MINERALS PROGRAM INSPECTION REPORT PHONE: (303) 866-3567

MINE NAME: Cresson Project	MINE/PROSPECTING ID#: M-1980-244	MINERAL: Gold	COUNTY: Teller
INSPECTION TYPE: Aerial Inspection	INSPECTOR(S): Timothy Cazier	INSP. DATE: May 18, 2020	INSP. TIME: 08:06
OPERATOR: Cripple Creek & Victor Gold Mining Company	OPERATOR REPRESENTATIVE: None	TYPE OF OPERATION: 112d-3 - Designated Mining Operation

Photo 13. Altman backfill reclamation area (looking NW).

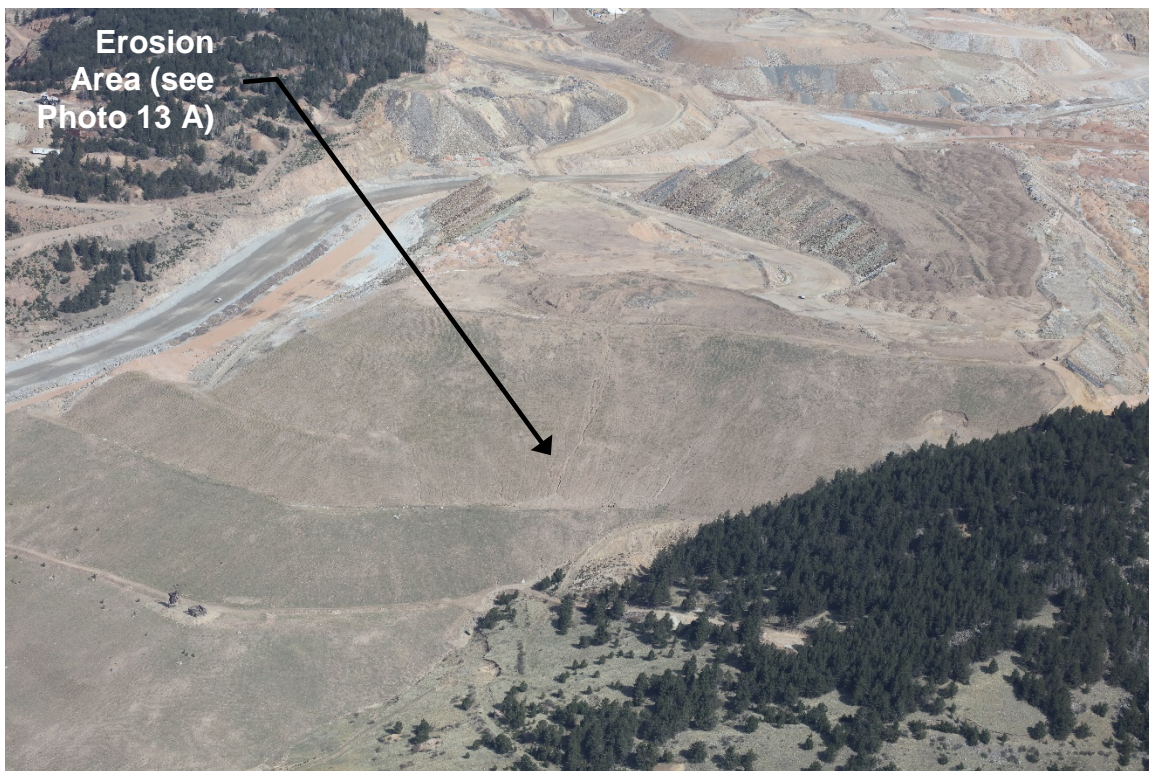
East Cresson Overburden Storage Area (ECOSA) / Altman Backfill Reclamation: Reclamation grading was observed on the south end of the ECOSA (**Photo 12**). Large rills and gullies were observed in the Altman Backfill reclamation area (**Photos 13 and 13A**). The largest gully has a significant fan of deposited sediment on the bench below it. Based on Rules 1.1(59), 3.1.5(3), 3.1.6(3), the Division would not be able to release reclamation in this condition. [We recommend repair and cite this as an example for limiting the distance between reclaimed stormwater catch benches and cross channels to something closer to 200 to 250 horizontal feet \(~100 vertical feet\).](#)
